Our ref: D37124/PK

Re: Supplementary Soil Sampling – Old Main Road, Fleet Hargate

Comments from Environmental Protection Officer

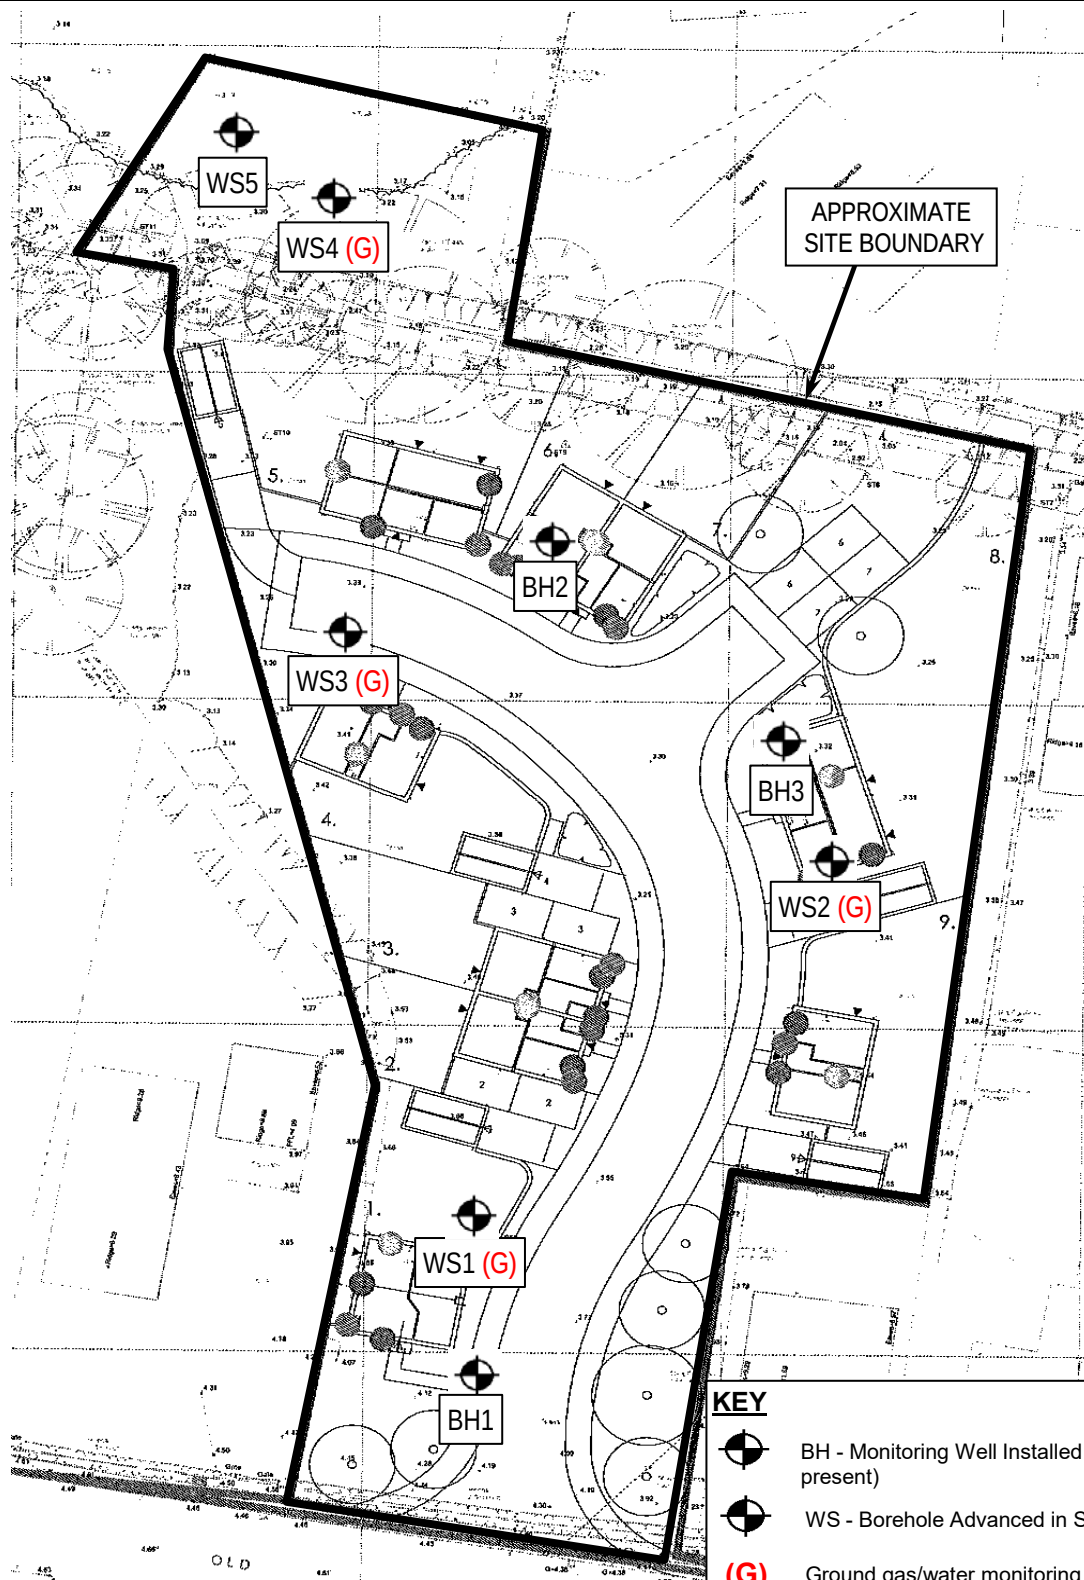
Please could the consultant clarify the situation with the near surface soils? The logs and text note that the site is underlain by topsoil, but the plates are labelled as 'made ground'.

There has been no investigation at all into the area of the former pond. This comprises the majority of the garden area of plot 5, and as such some investigation in this area is required.

The site has been classified as CS2, however only three ground gas monitoring visits have been undertaken. Generally, a minimum of 6 visits are required in order to consider the site adequately characterised.

No details of the proposed ground gas protection measures have been submitted at this stage. Guidance as to the requirements, including the need for validation, can be found in the document 'YALPAG Technical Guidance - Verification requirements for gas protection systems v1.1' which can be downloaded from <https://www.sholland.gov.uk/article/11653/Planning-Application-Consultations-Condition-Discharge>

As such, I recommend that part i of condition 22 of H05-1235-18 be discharged, with parts ii-iv outstanding.
